**Conda/Woodall Mountain Mine  
Pedro Creek Overburden Disposal Area  
Early Action**

**Engineering Evaluation/Cost Analysis**

**J.R. Simplot Company**

**October 26, 2010**

**Figure 7-1 Summary of Infiltration Reduction Relative to Cost**

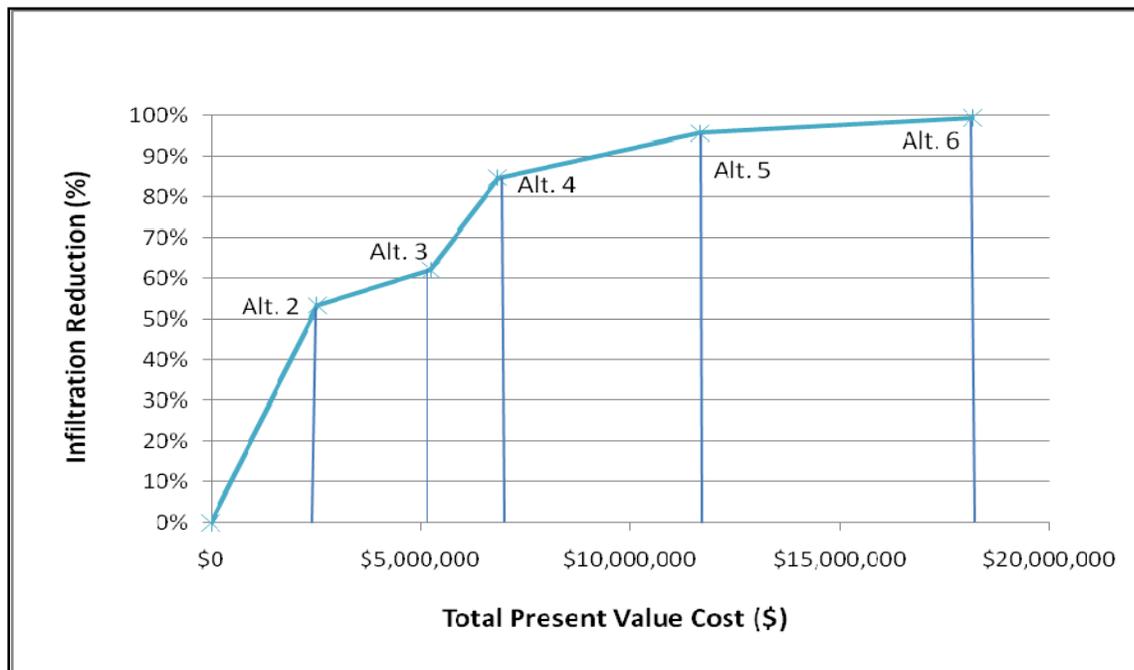
Pending adequate resolution of General Comment # 1, the Agencies may concur with the conclusion that Alternative 4 is the most cost effective among the alternatives that are most likely to result in significant reduction of COPCs in groundwater and surface water downgradient from the ODA. However, the presentation of cost-effectiveness in Figure 7-1 is not the best method for demonstrating cost effectiveness among the alternatives. The attached Table 7-2 provides an alternative demonstration of cost-effectiveness that would better justify Alternative 4 as the Recommended Alternative. As can be seen from Table 7-2, Alternative 4 is the most cost-effective alternative in terms of infiltration reduction among the alternatives that best meet the RAOs (Alternatives 3 through 6). Figure 7-2 and the text after the first two sentences in the paragraph following the bulleted items on page 50 should therefore be deleted. Table 7-2 should replace Figure 7-1, and the deleted text in this paragraph replaced with the following:

FIGURE 2-2  
**SURFACE GEOLOGY MAP**

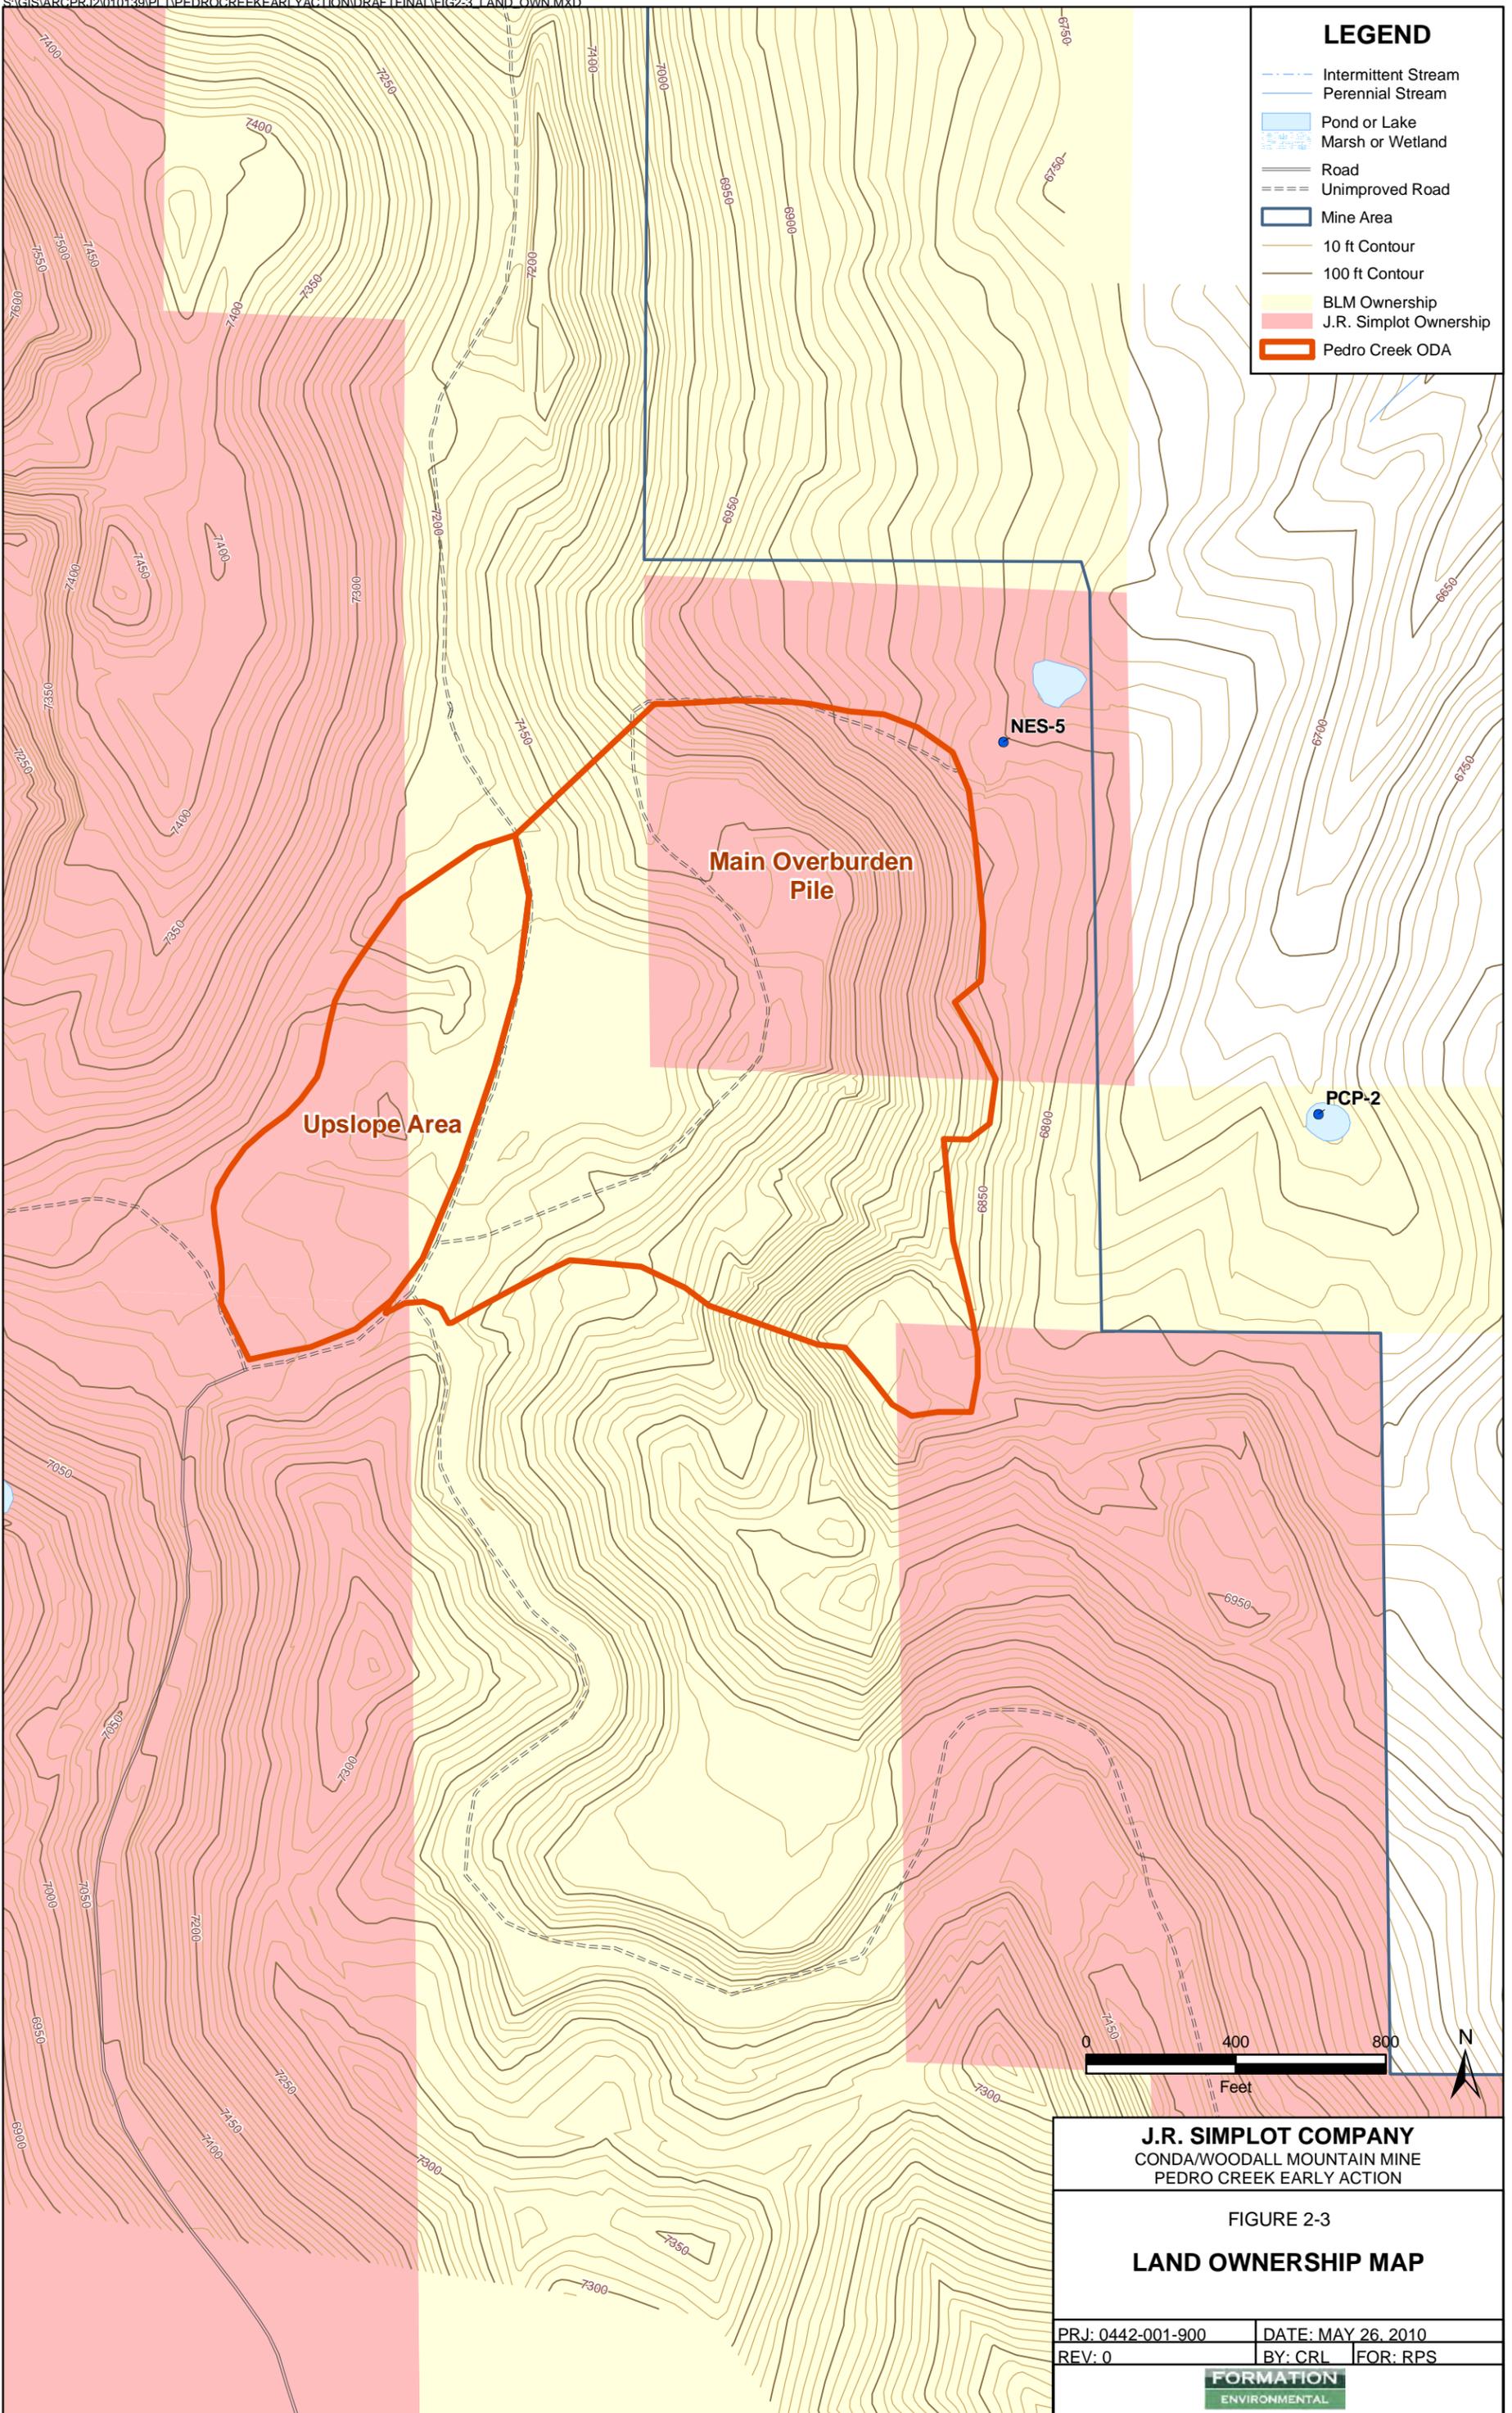
- 4) **Section 2.3.3, page 6, paragraph 3; Figure 2-2, and Appendix A**  
a) DEQ appreciates the effort to provide site-specific geologic interpretation based on exploration borings, mining records, and observations. This greatly improves our understanding of natural conditions, and hydrogeologic features at Pedro Creek. The text indicates that a significant structural feature underlying the Pedro Creek ODA is a SE-NW trending transverse fault, with a vertical offset of 150 to 200 feet. The description in Section 2.1 of historical mining operations in this part of Woodall Mountain suggests that the fault controlled the progression of mining, and suggests that it may contribute to channeling of recharge waters within the ODA and bedrock. However, the fault is not well depicted on Figure 2-2. There is a SE-NE trending fault trace bisecting the ODA in plan view, but the apparent motion is not depicted, nor is there any visible offset of section in plan view or in the cross sections. Cross Section Line # 9 appears to intersect this fault, but the fault is not depicted in the cross section. The

- b)** Cross Sections 8 and 9 depict the locations of several exploration boreholes completed in 1961, 1967, and 1969. The Figures in Appendix A should be updated to identify the boreholes that are depicted in Figure 2-2; it is very hard to read the penciled labels in Appendix A. Additionally, the boreholes/wells on Figure 2-2 should be shown as narrow columns or lines, not wide boxes. Any offsets to the Meade Peak Member or Wells Formation based on the boreholes that are mapable based on the scale should be shown as offsets to bedding in the cross sections. (see Comment # 20, for other concerns regarding Figure 2-2).

The text states, “Between NES-5 and PC-5, Pedro Creek loses flow and does not gain any flow until around PC-2 . . .” However, Figure 2-2 depicts a gaining portion in reach 1, upstream/upgradient from wells GW-28 and GW-29. Check for accuracy and correct this inconsistency.

**20) Figure 2-2**

i) **Please see additional concerns identified in Specific Comment # 4 regarding Figure 2-2.**

**Response to Comment:** Figure 2-2 will be revised to better depict the fault zone and the resultant offset to bedding. Cross section line 9 does not intersect the fault; therefore the fault is not depicted in the section. Appendix A will be revised to include a trace of the fault on the relevant photos.

**Response to Comment:** The boreholes that are depicted in Figure 2-2 will be identified on the Appendix A figures. Figure 2-2 will be revised to show narrower columns for the exploration boreholes. The exploration holes do not indicate offsets to the Meade Peak Member or Wells Formation that would need to be depicted on the cross sections.

**PEDRO CREEK ODA  
MINE GRID, AND  
FEATURES**

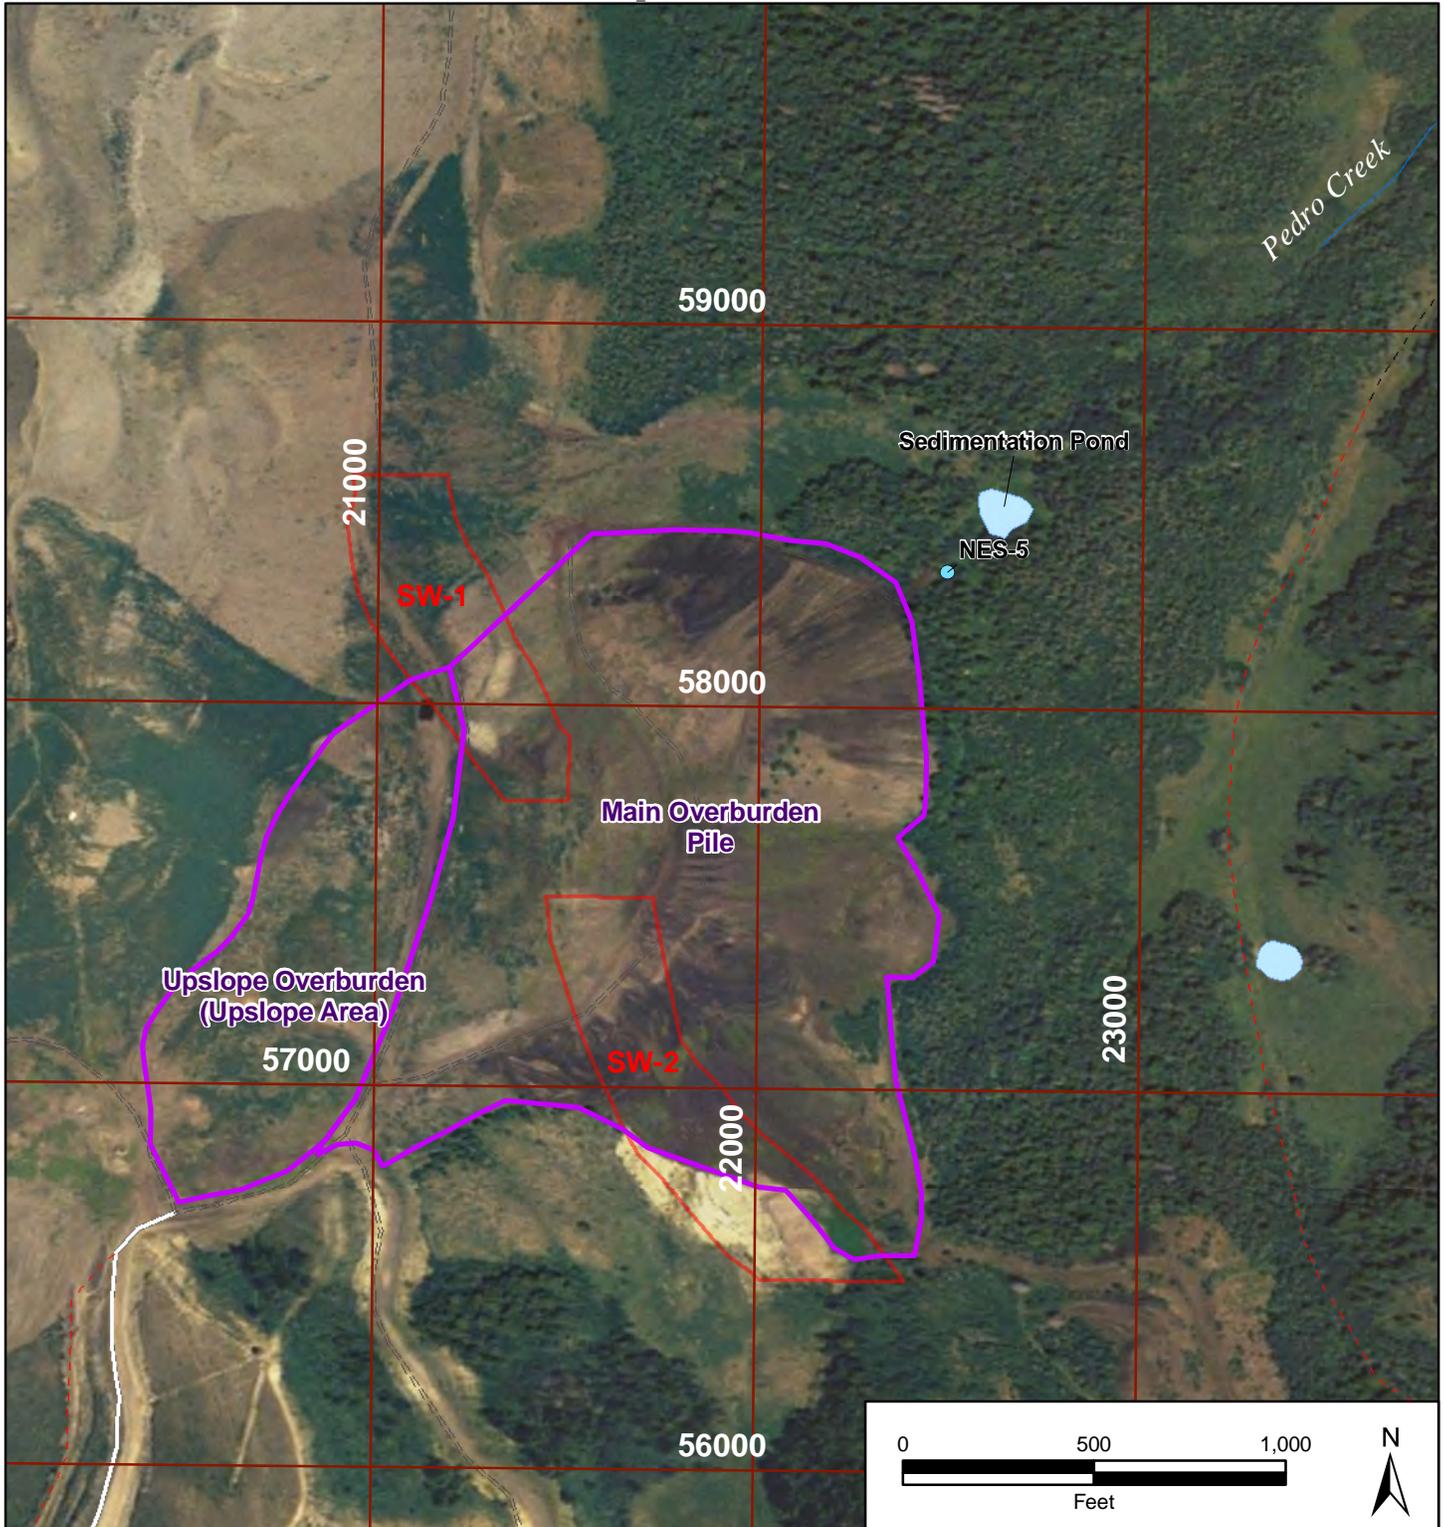
## 21) Appendix A, Figure A1

**Response to Comment:** Figure A1 will be revised to make the scale and the north arrow more legible.

**Response to Comment:** Figure A1 will be revised to make the symbol for NES-5 more legible and the sedimentation pond will be added to the legend.
